Re: PA 10-5825, Prime Wildlife Shorelands Combining District (PW) Preliminary Investigation for proposed subdivision, Idylewood 4th Addition.

Exhibit A
Conditions attendant to PA 10-5825
Preliminary Investigation for the Prime Wildlife Combining Zone (PW)
for 4th Addition to Idylewood

Preliminary Investigation in the Prime Wildlife zone *Staff Report*

Report Date:	April 19, 2012
Department File:	PA 10-5825
Property Owner/Applicant:	Benedick Holdings LLC
Agent:	Clint Beecroft/EGR & Associates
Property Address:	None issued
Assessor's Map:	18-12-10.4 Tax Lot: 400, 401 & 801
Acreage:	46+ acres
Base Zone:	Suburban Residential (RA, LC 10.135
Combining Zone:	Prime Wildlife (/PW) & Beaches & Dunes (/BD)
Comprehensive Plan:	City of Florence Comprehensive Plan (1988 version)
Site Visit Date:	March 29, 2012
Staff Planner:	Jerry Kendall, 541-682-4057

PRELIMINARY SUBDIVISION PLAN FOR IDLEWOOD FOURTH ADDITION SUBDIVISION

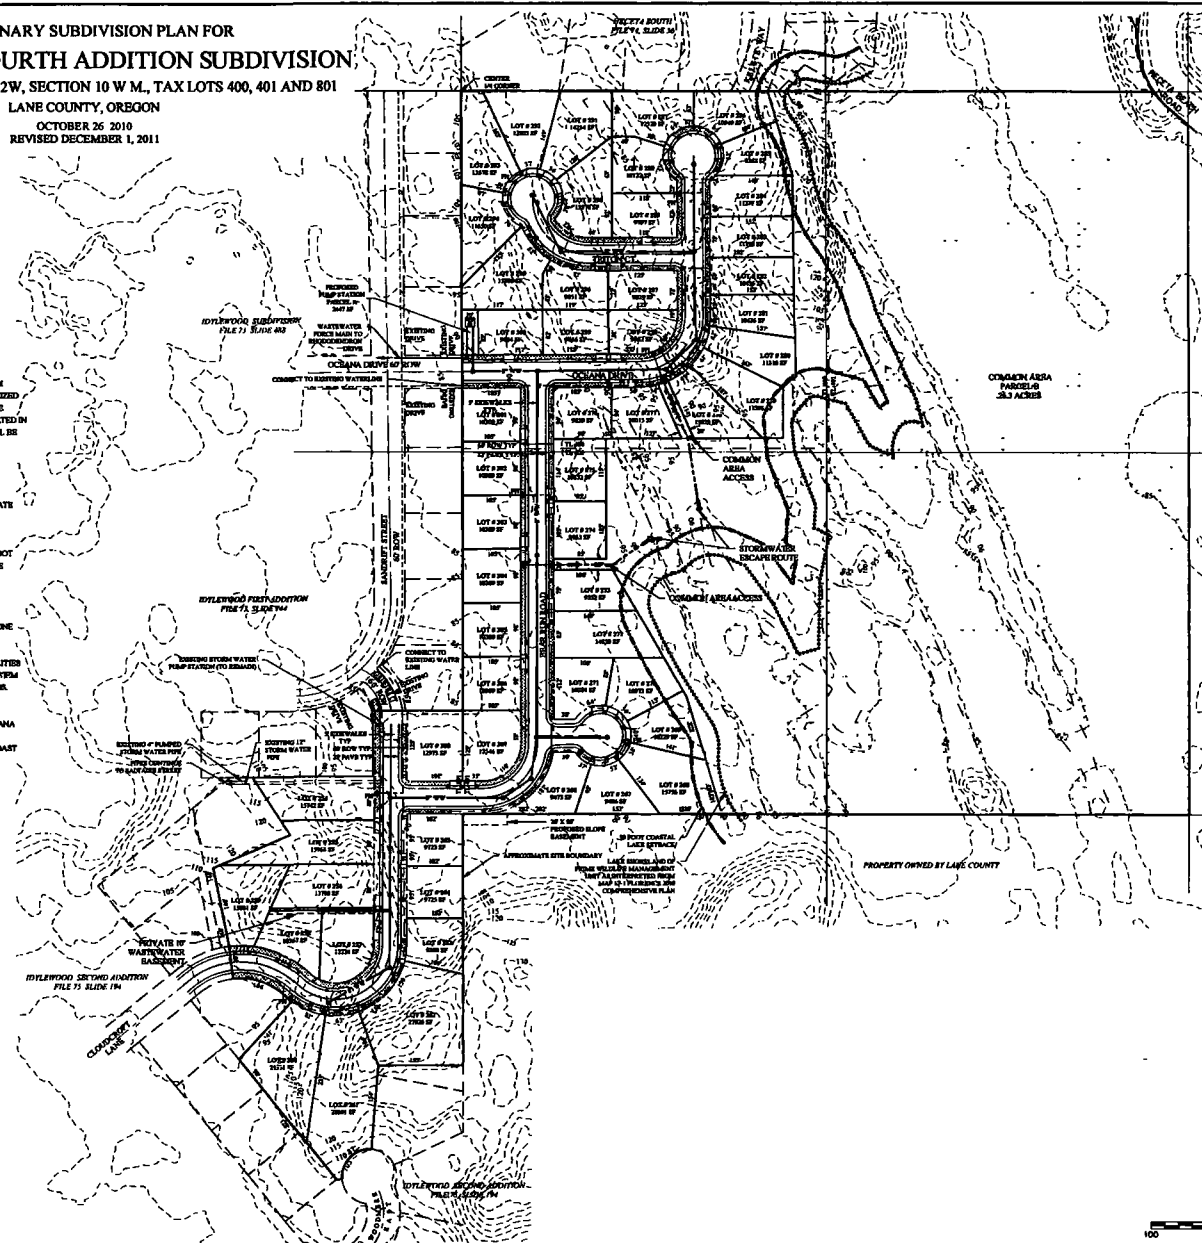
Aside from the above rationale, the "pond" is shown (Attachment A) to be contiguous with the remainder of the seasonal lake in the DSL delineation, WD# 07-0747. Wetlands share three primary characteristics: hydric soils, hydrophytic plants, and prolonged water saturation. The fact that DSL has designated the "pond" as contiguous with the remainder of the designated wetland lake adds reason to also include it into the PW zone.

HECETA SOUTH

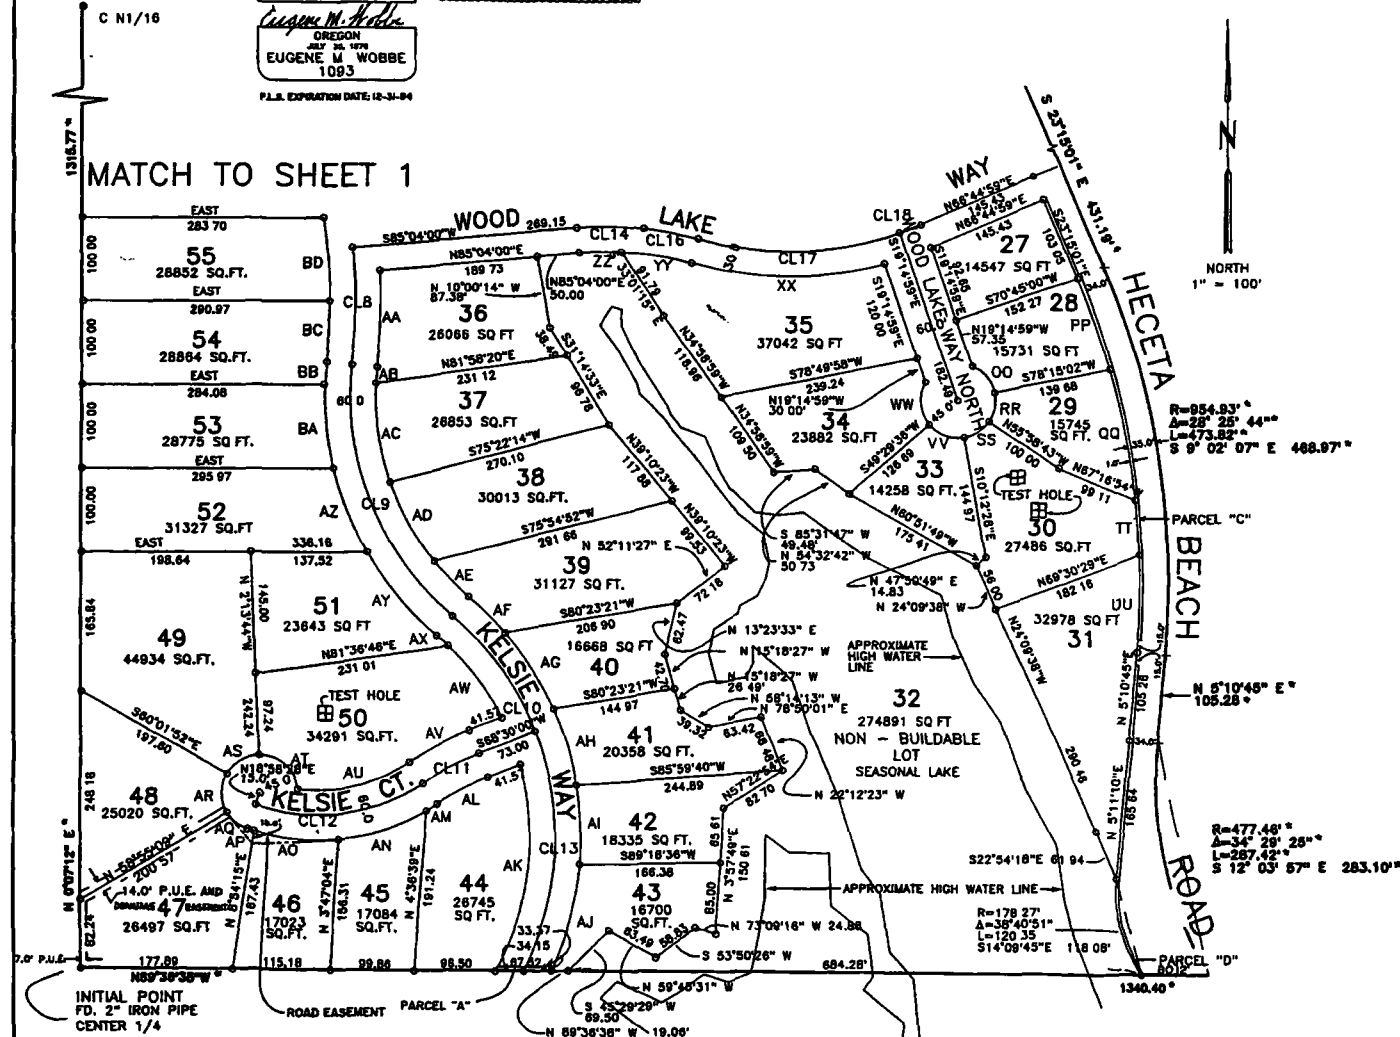
The first area is at lot #285. Lane Code Chapter 15/Roads requires that Kelsie Way be extended southward to connect with Oceana Drive. During the review of the Heceta South subdivision, the extent of the PW zone was set at the "approximate high water line" as so marked on that plat, Attachment C to this report. The 50' buffer required by LC 10.245-30(5) was also established accordingly, and no development was permitted to occur inside that buffer. The outer perimeter of lots 30, 31, 33-43 of Heceta South were set accordingly to be outside that buffer. In addition, Kelsie Way was also set enough to the west to be outside the buffer and allow for its construction. According to documents submitted by the agent for this investigation, the "approximate high water line" on the Heceta plat equates to a calculated elevation of 87' msl.

IDYLEWOOD 4TH ADDITION
COASTAL OVERLAY SETBACKS
14 MARCH 2012
FLORENCE, OREGON

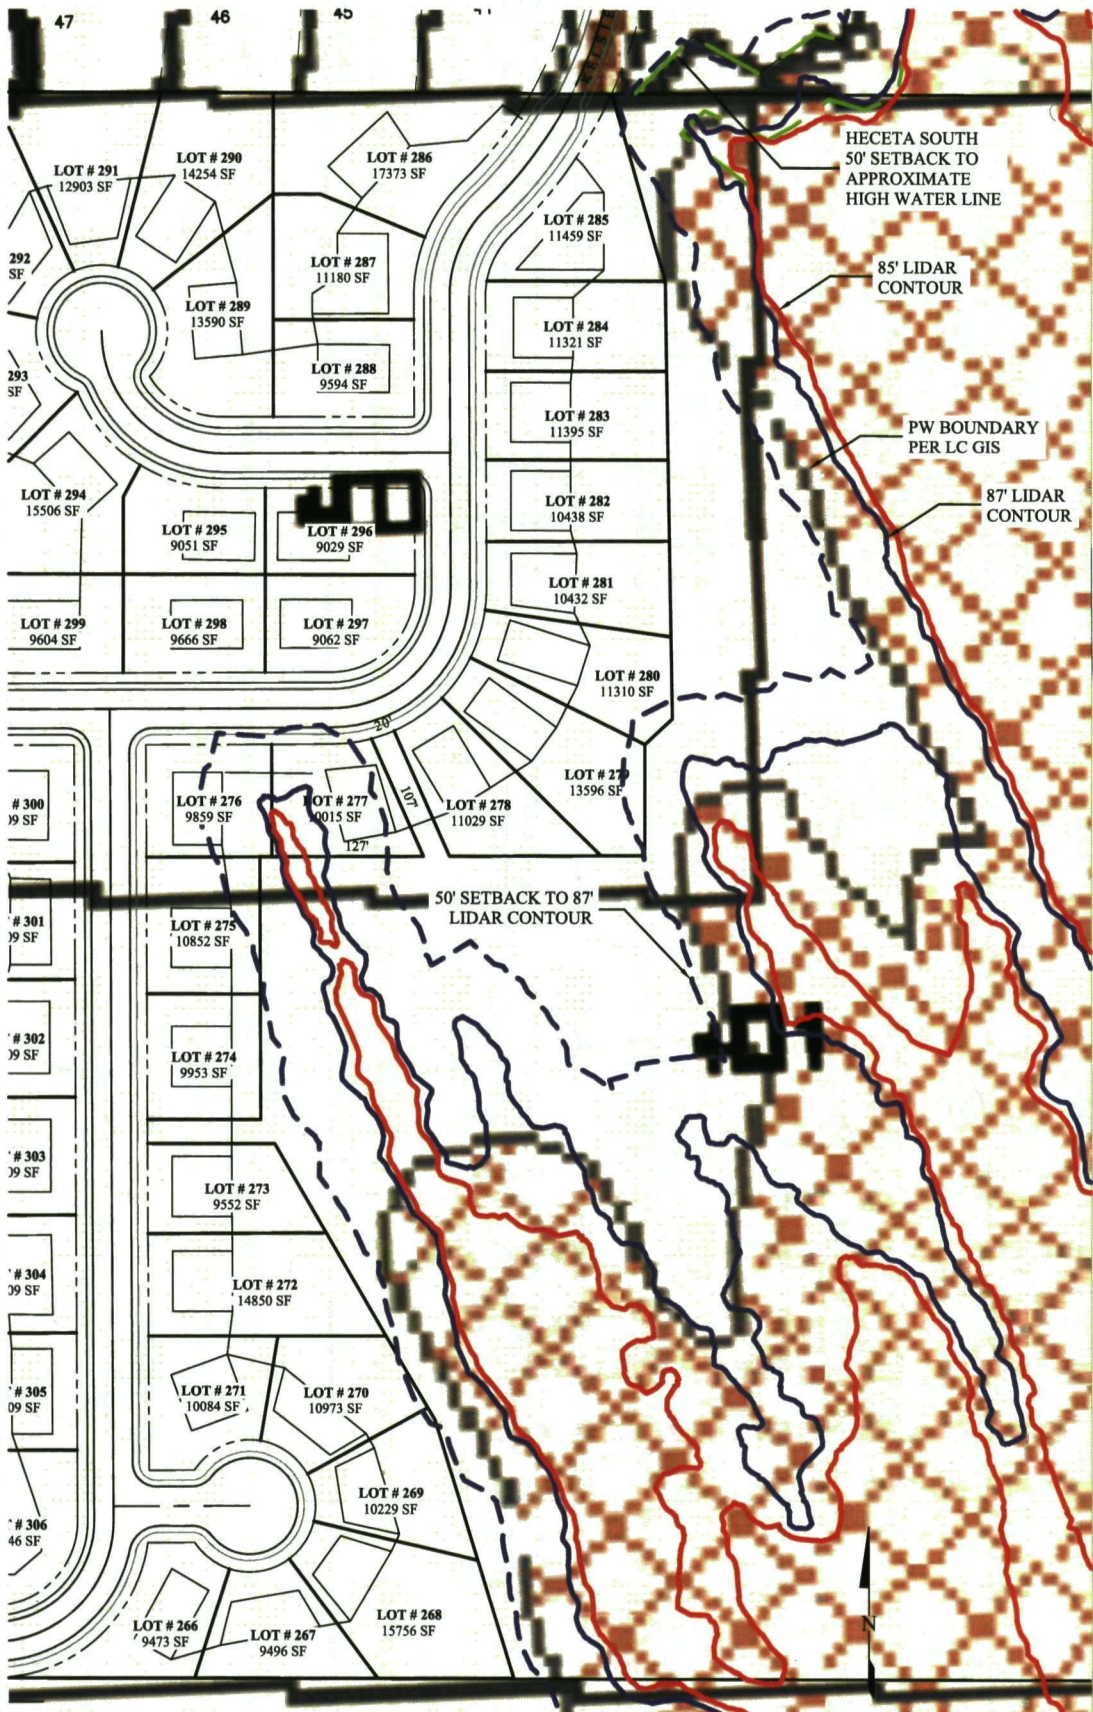
A comparison of Attachments A and D show that the majority of the seasonal lake along with the 50' buffer will have no consequence to proposed development of the property, except for two areas.

The second area is found proximate to lots 275, 276, and 277 of the proposed Idylewood 4th addition, an area where an arm of the seasonal lake extends towards those lots. Refer to Attachment D. This attachment shows an extended "pond" area (in red) which is detached from the main arm and covers

portions of lots 276 and 277. This “pond” raises the question as to whether or not it should also be considered part of the PW zone (it is noted that in any event the pond is part of the DSL accepted wetland delineation, WD 07-0747). A photo of the “pond” is found as Attachment E. The photo was taken from the north end of this feature, looking southward. The water in the pond was observed to be approximately 6” deep on that date. While staff did not traverse to the southern extent of the pond, small trees and brush could be observed at the southern end, verifying that the pond is somewhat separated by the main arm of the seasonal lake, at least during portions of the year, enabling such growth. The photo was taken on 3-29-12, the end of the month of March, which was the 5th wettest on record for Eugene at 9.94”(records for Florence were not available, but is generally greater than Eugene). Source: <http://www.kval.com/news/local/5th-wettest-March-on-record-for-Eugene-145700645.html>). See Attachment F.

The question arises as to whether or not the aforementioned “pond” which is found near proposed lots 276, 277 should be included in the PW zone. As seen on Attachment D, it connects to the main lake body

when water is at 87' msl but not when the water level is at 85' msl. Unlike the portion of the lake near the border with Heceta South subdivision, there are no steep embankments at this location. However, at the (accepted) 87' msl, this "pond" is contiguous with the main body of the lake. In addition, at the 87' msl level this "pond" qualifies as land lying between the mean high, high water and mean low watermark of coastal water body.

1. The PW boundary is set at an elevation of 87' mean sea level (msl) around the seasonal lake as illustrated in Attachment D (note: 87' msl = "87' LIDAR Contour" on that attachment). Note: this boundary is independent of the wetland delineation (WD#07-0747) approved by the Oregon Division of State Lands (DSL). Actions within the designated wetlands are subject to approval by the DSL.

2. No structures shall be allowed within 50' upland of the above boundary (measured horizontally, LC 10.245-35).
3. No topographic modification shall occur within 50' upland of 87' msl. PW boundary (measured horizontally). There is no variance option to this standard. (LC 10.245-30(5)).

Conclusion: Subsections (ii) and (iii) apply. The PW zone boundary is established by the Planning Director at 87' msl. Lane Code 10.245-35 requires a 50' structural setback from the 87' msl level. No topographic modifications are allowed within this setback area. There is no variance option to this standard. This will require a redesign of lots 276, 277, and perhaps 275, along with a portion of the sidewalk/road north of 276 and 277. Lots 279 and 280 are nominally within the "no touch" buffer, but this can be so listed within the approved CC & R's to properly advise future owners.

The PW boundary has been established at 87' msl around the seasonal lake as illustrated in Attachment D. Conditions safeguarding this resource are listed in Exhibit A.
